Civic Center Station Area Plan Advisory Committee
Wednesday, July 11, 2012; 7:00 – 9:00 p.m.
Volunteer Center, Guide Dogs for the Blind
350 Los Ranchitos Road

**DRAFT CIVIC CENTER STATION AREA PLAN
SUMMARY OF COMMENTS**

The Draft Plan describes the proposed height changes in text but does not contain an exhibit showing the changes. This has caused some confusion, especially in the Redwood Highway Area. Staff recommends that an exhibit be included that clarifies the Committees intent. Following is the current Draft Plan text; information on existing building heights in the area; 3 alternatives on the Redwood Highway Area; and a base map for sketching other alternatives.

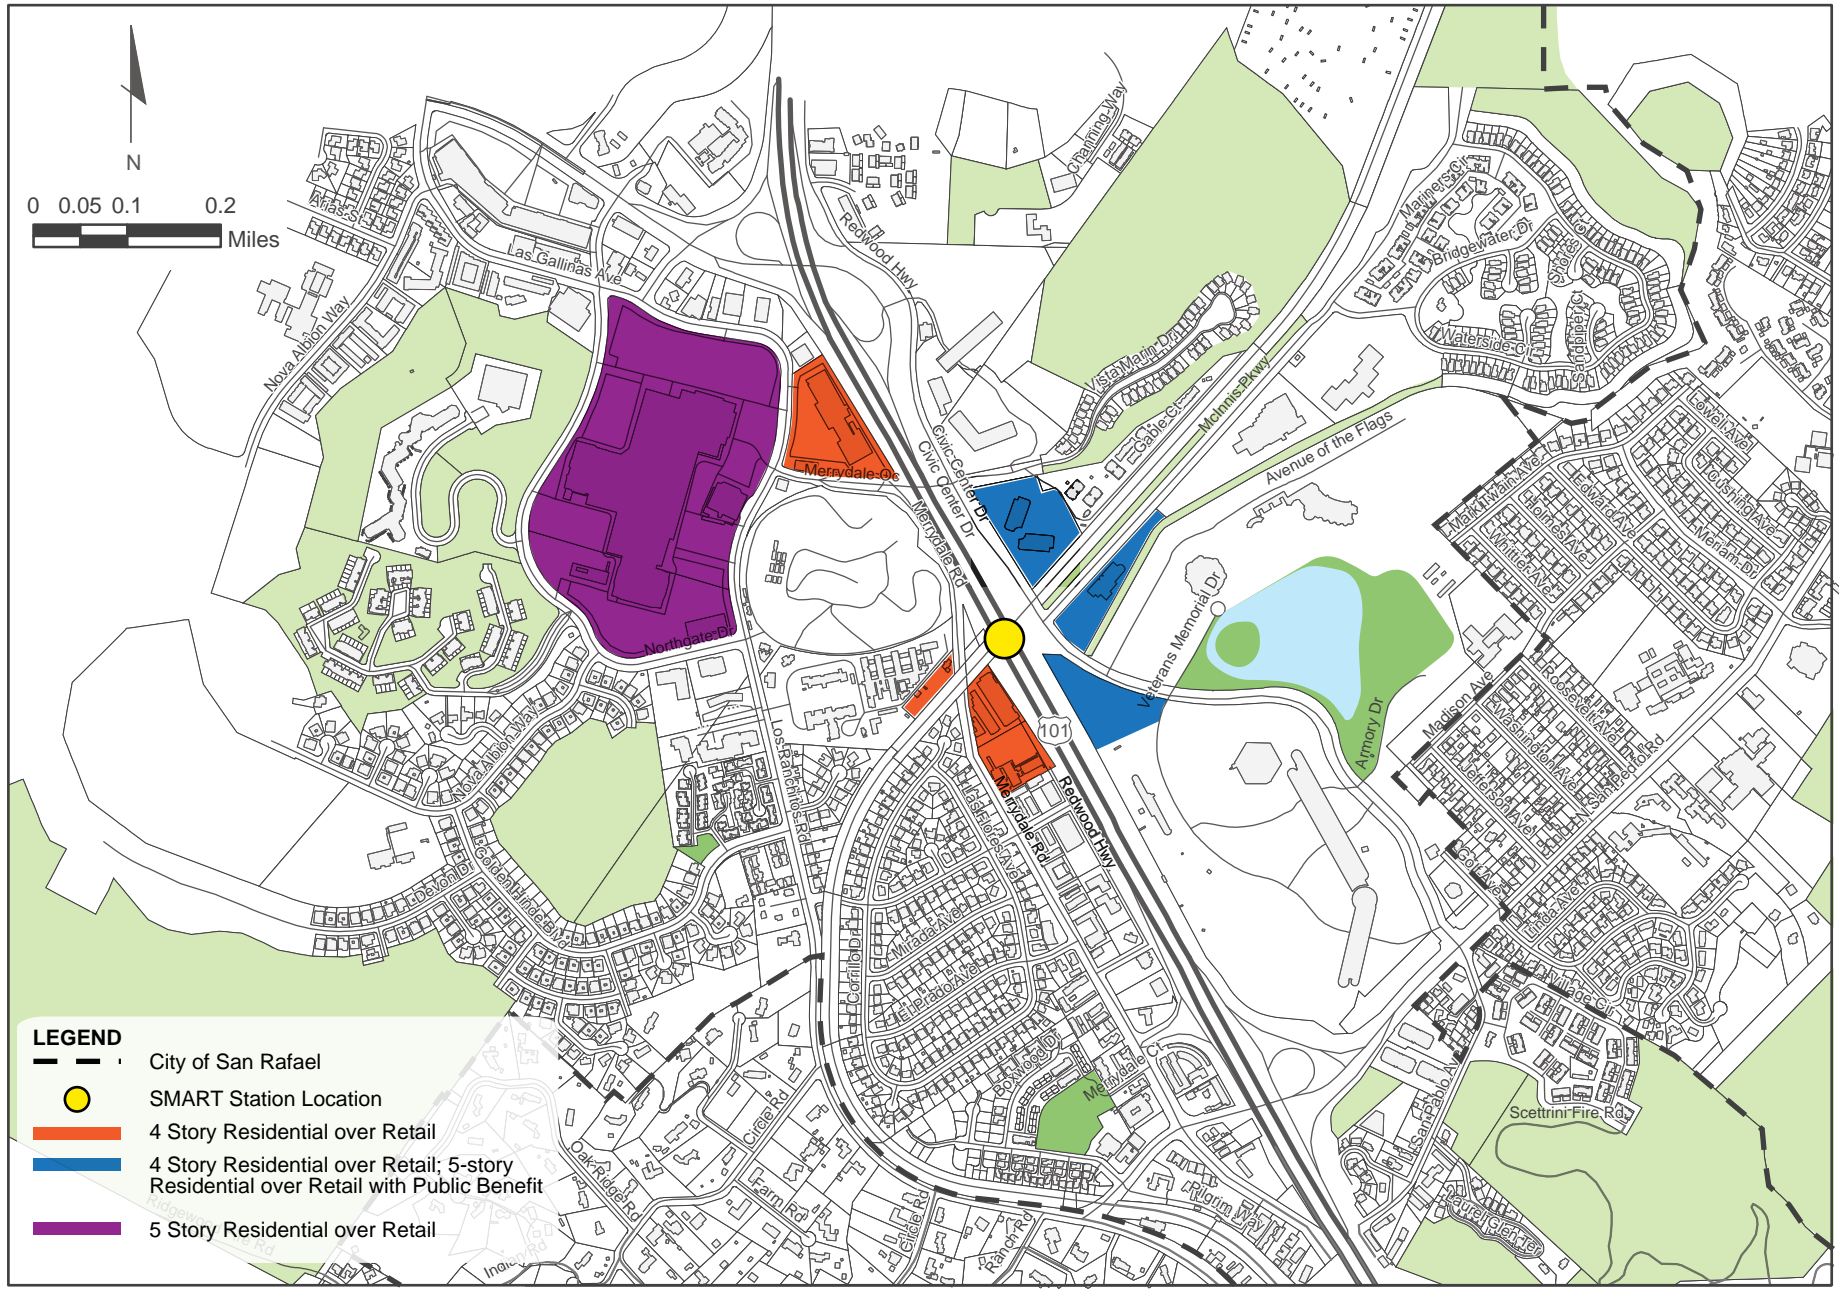
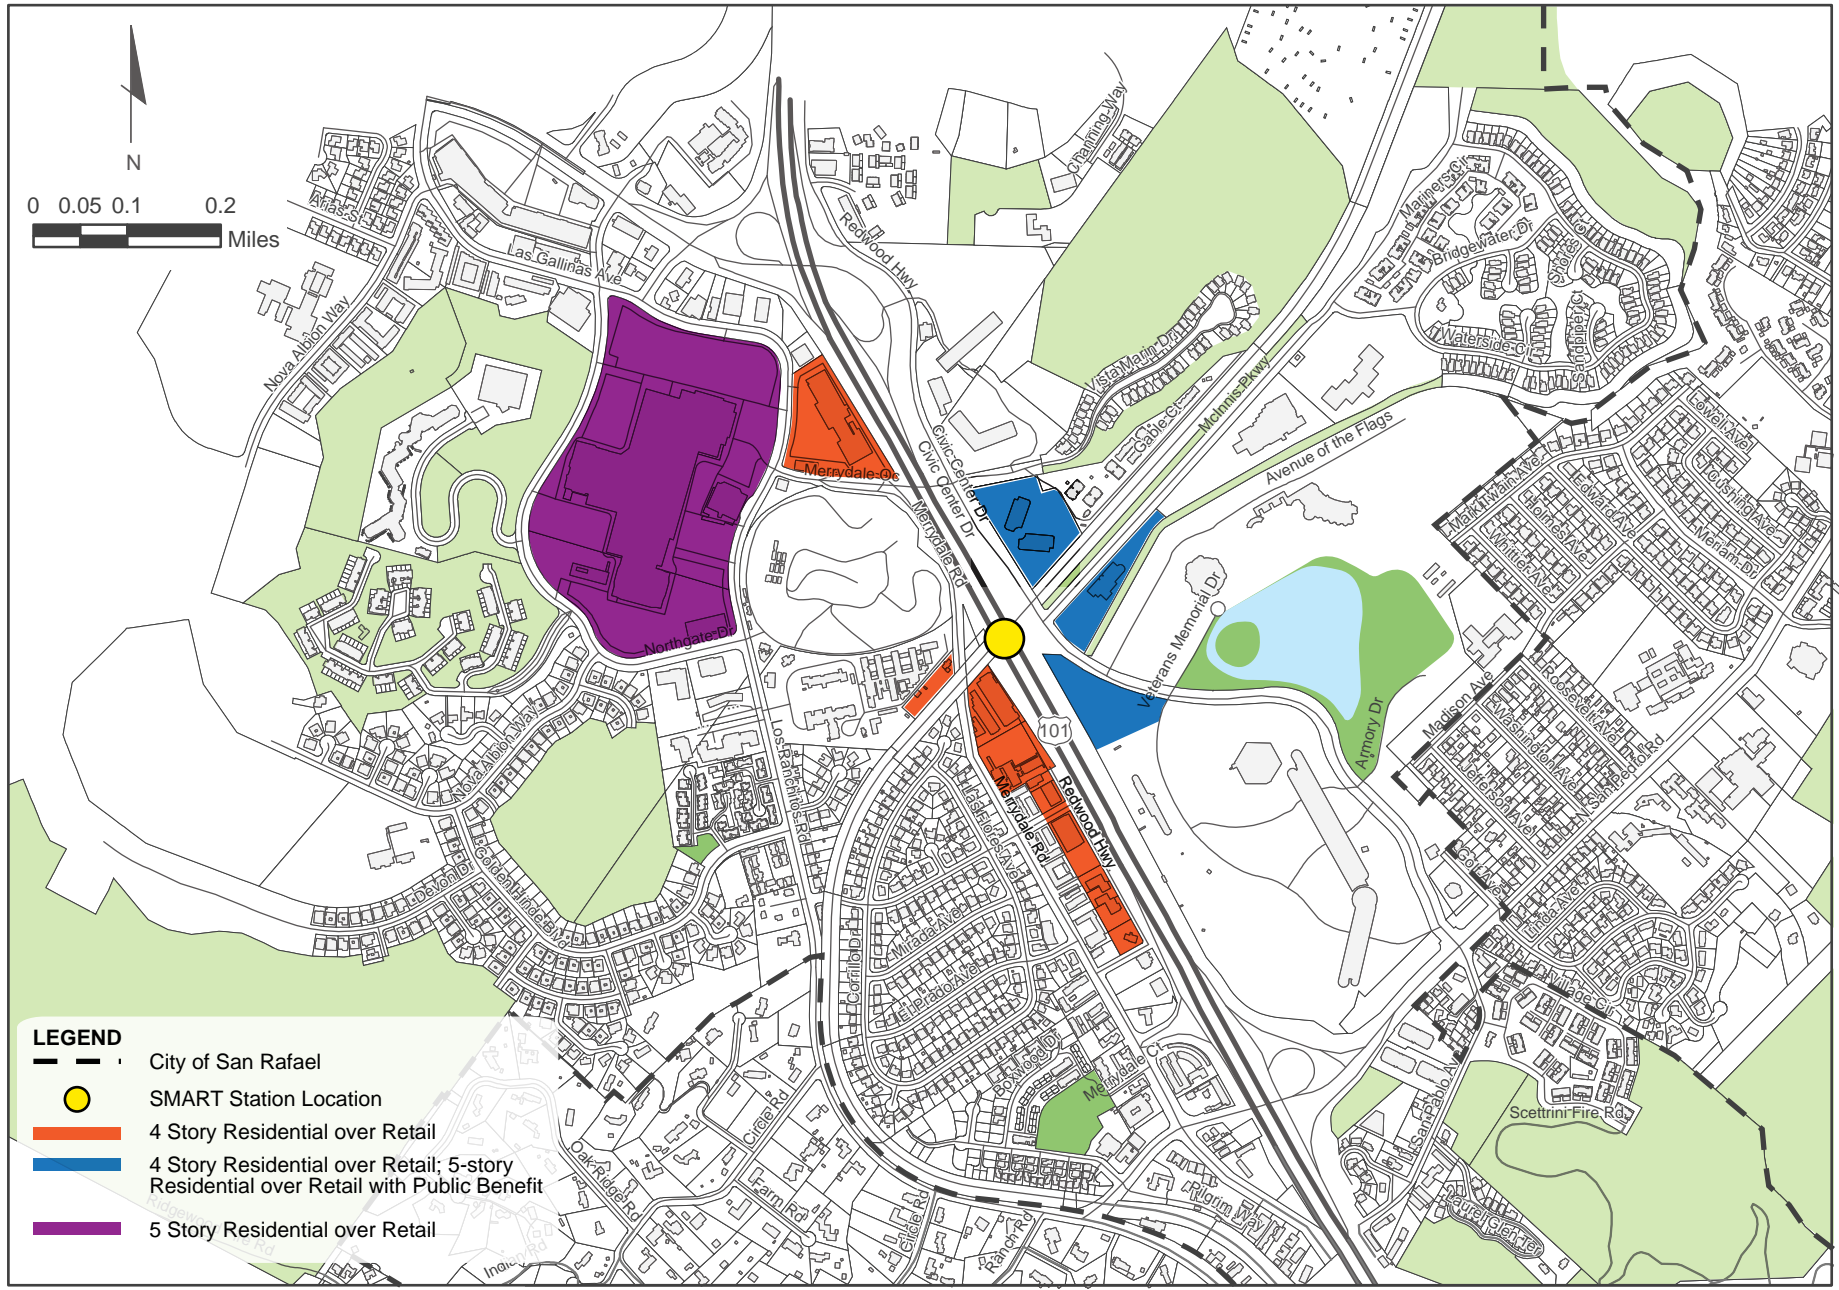
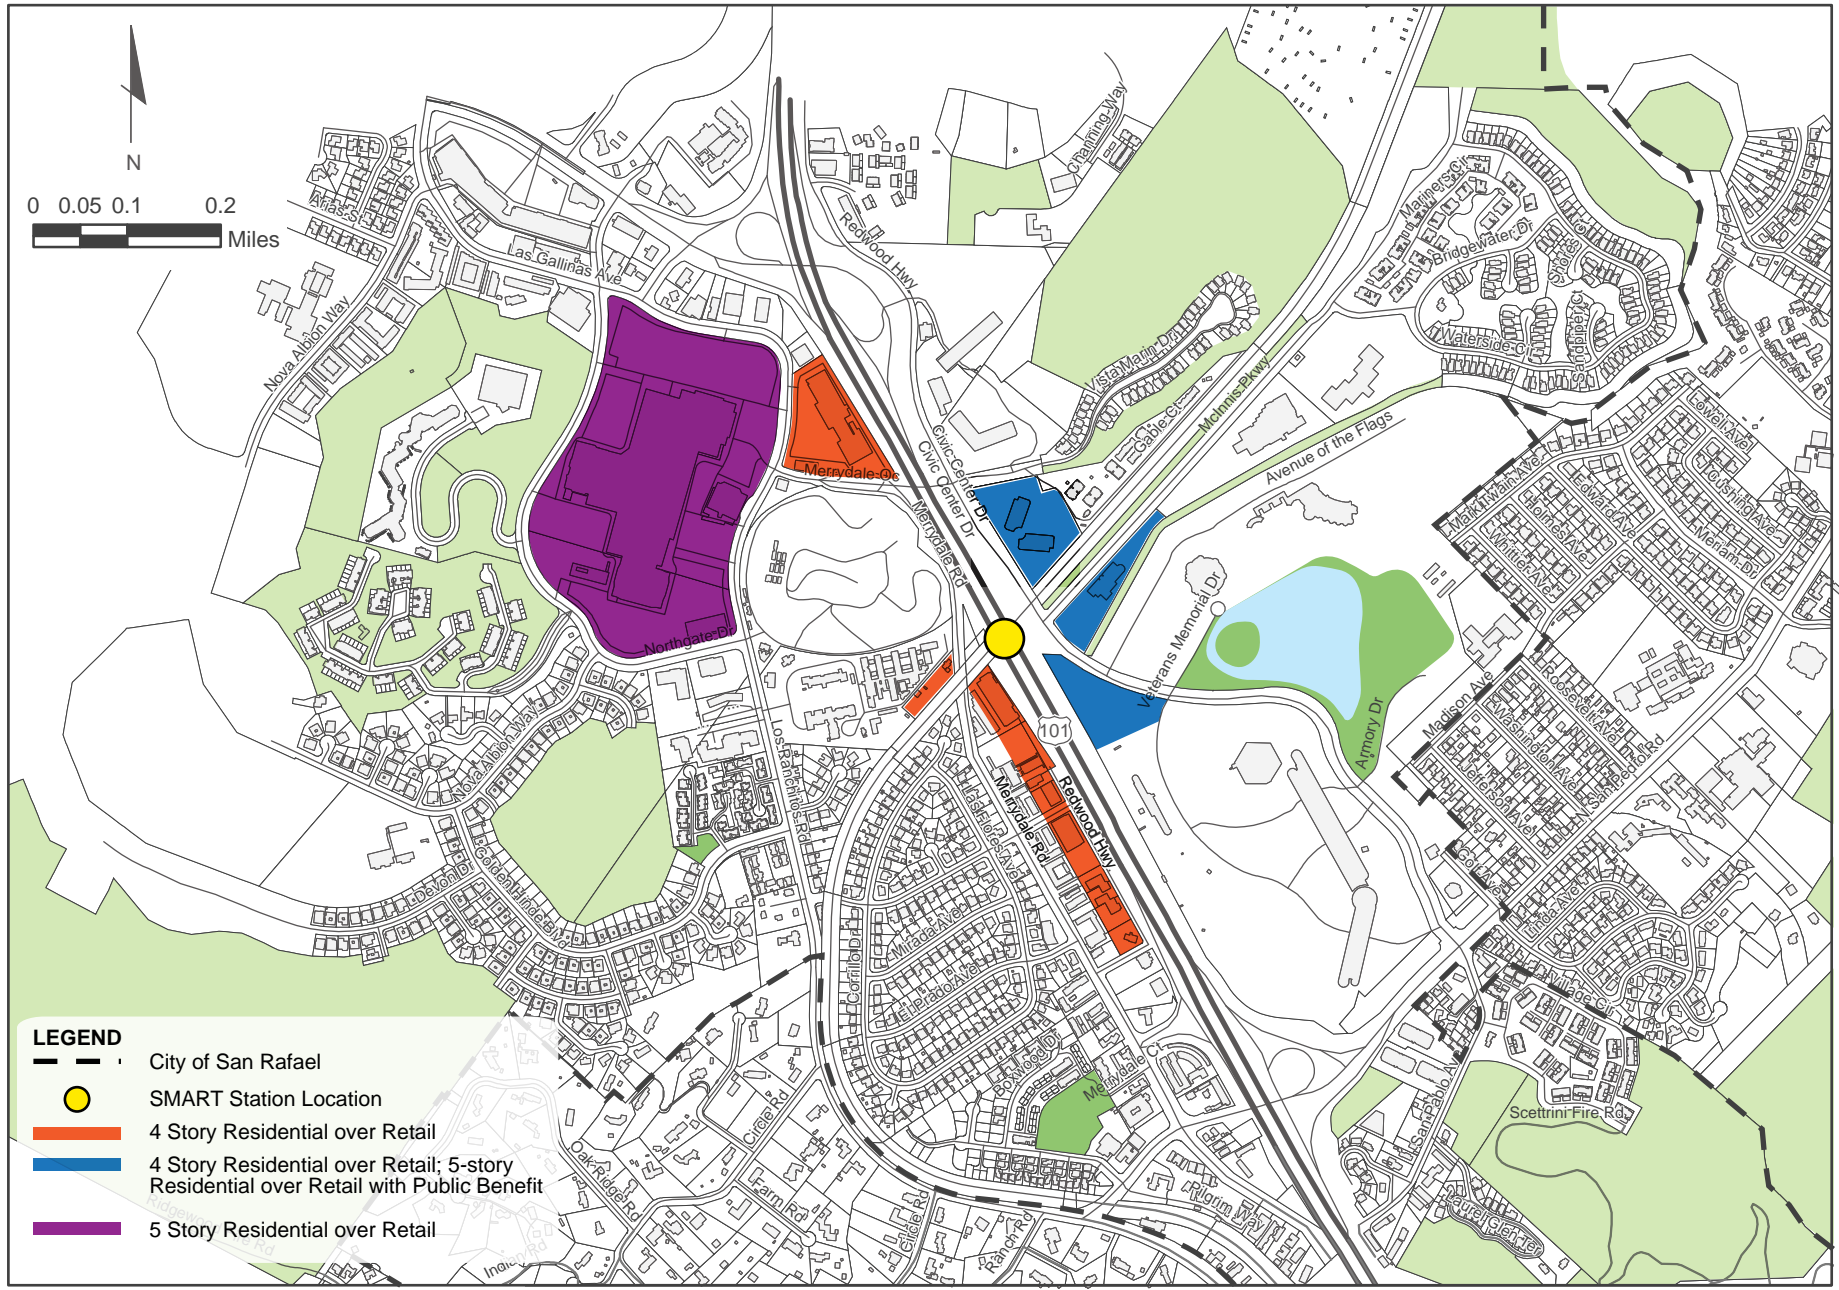
The Plan describes heights in stories; the Zoning Ordinance uses feet.

In general 3 stories = 36 ft. 4 stories = 48 ft. and 5 stories = 60 feet.

Macy's = 57 ft., Sears = 54 ft. Mervyn's = 43, Auto Desk = 38 ft. and Embassy Suites = 57 ft.

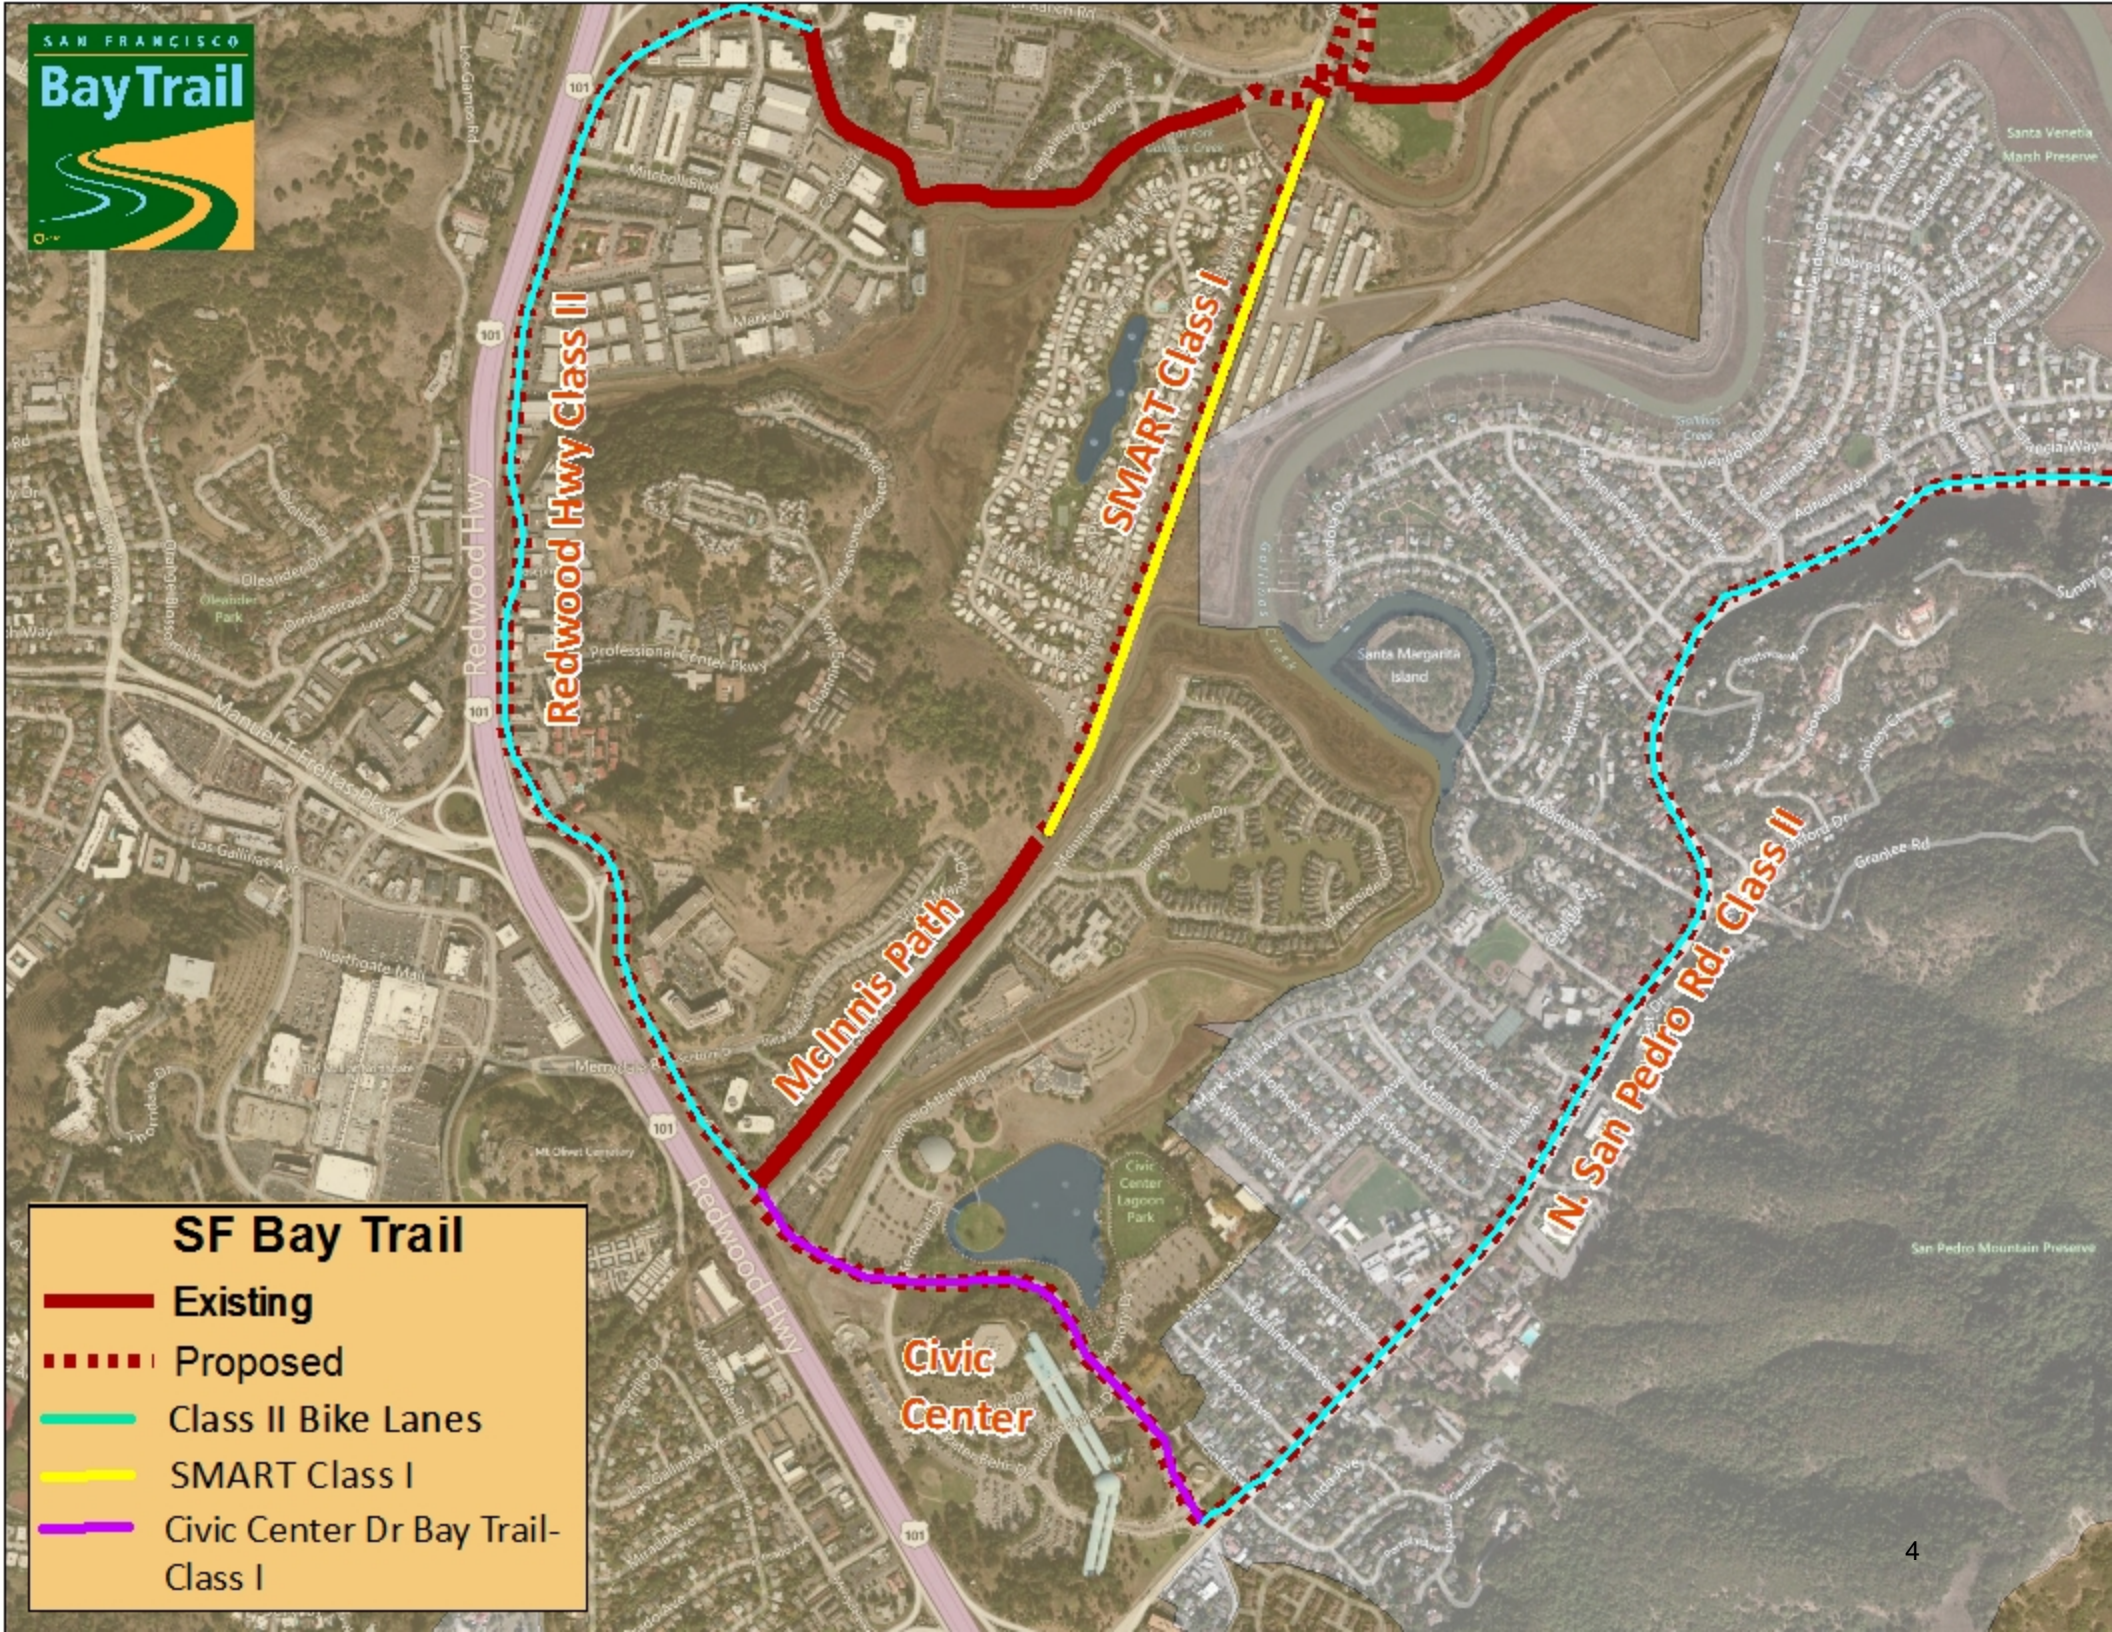
While the Bay Trail is mentioned in passing in the Civic Center Station Area Plan, we would like to take this opportunity to highlight desired conditions in the study area. As shown on the attached map, we would like to see the following improvements incorporated into the Plan:

A multi-use path on Civic Center Drive meets the goals of the San Rafael Bicycle & Pedestrian Plan, the Bay Trail Plan and Guidelines, aligns with SMART's overall plan for a 70-mile MUP, and is the best possible way to encourage SMART riders

to access the Civic Center via non-motorized transportation. Please include a Class I facility in near term planning for the Civic Center Station.

2. **Civic Center Drive/Redwood Highway Class II:** Between McInnis Parkway and Smith Ranch Road, the Bay Trail is pleased to see the SAP's plans for a Class II bike lane.
